Service Bulletin

Model : GP605

No.: GP605-005 Rev. 1
(FF-T01-K1-000009-02)

Subject : PREVENTING JAMS WHILE READING AN ORIGINAL

Fig. 1

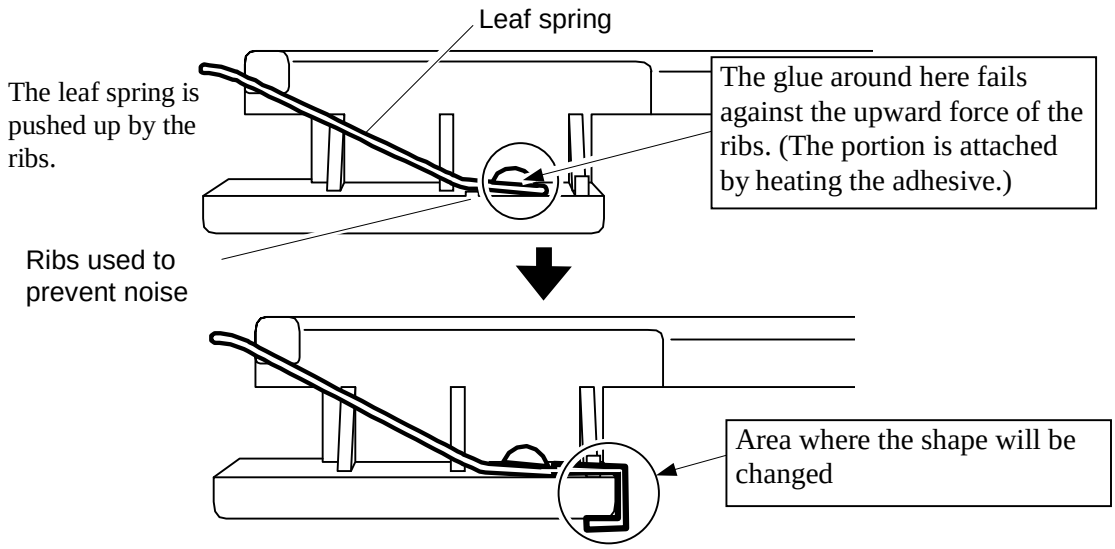
<Cause>
A portion of the leaf spring of the slide guide (rear) found on the ADF pickup tray can fail against the upward force of the ribs found under the spring, resulting in detachment.

- Tentative Measures
  The ribs of the slide guide (used to prevent noise; see the figures below) are shaved off to limit the stress against the glued portion (switch-over on and after March 30, 1999).

- Permanent Measures
  In addition to the tentative measures above, the shape of the leaf spring will be modified to prevent stress on the leaf spring (see the figures below; switch-over on and after April 13, 1999).
